**FINDINGS AND RECOMMENDATION
OFFICE OF PLANNING AND ZONING
ANNE ARUNDEL COUNTY, MARYLAND**

CASE NUMBER: 2023-0240-V

The applicants are requesting variances to allow retaining walls, access stairs and to perfect a platform with less setbacks and buffer than required and with disturbance to slopes of 15% or greater on property located at 608 Tower Bank Road in Severna Park.

SHEET 1 OF 1
VARIANCE PLAN
EXISTING AND PROPOSED DRAINAGE AREA MAPS
608 TOWER BANK ROAD

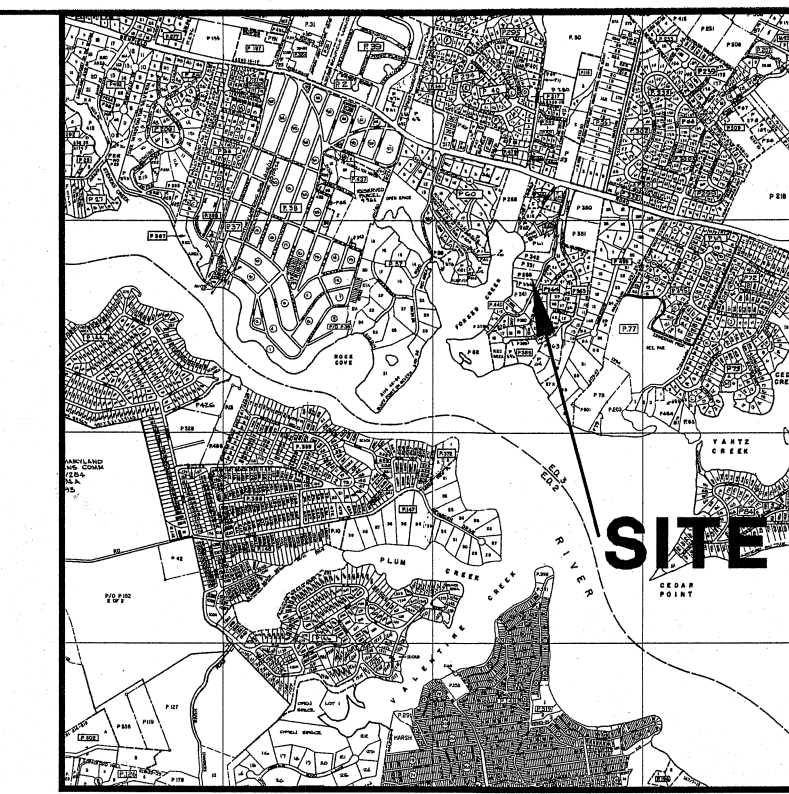
The **Critical Area Team** has no objection to the in kind replacement of the existing steps and landings. However, aerial photos indicate that the platform has been expanded beyond what

originally existed and beyond the 3' x 6' platform shown on the plan. Aerial and enforcement photos also show significant clearing of mature trees on the slope. The platform expansion cannot be supported and should be removed. Storage of watercraft can occur at the top of the slope and be transported to the pier by tram or at the base of the slope, but their Office cannot support clearing on and disturbance of steep slopes for that purpose.

Retaining wall locations should be clearly shown/labeled on the site plan.

Additional explanation/photos should be provided to justify the 3x6 platform.

The Administrative Site Plan should clearly show the footprint of the retaining wall, water access steps and landings.

2023-0240-V (detail w/ approx measurements)

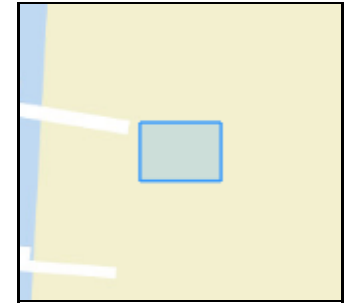
² Construction details were not provided for the retaining wall, water access stairs, small watercraft storage deck or tram landing. As measured from the Administrative Site Plan, the storage deck is approximately 7.5' x 11.5' and the tram landing is 3' x 6' (approximate total 104 sqft); however, as measured from aerial photography, the storage deck is an irregular 10' x 11' and the landing is 3.5' x 5' (approximate total 122 sqft).
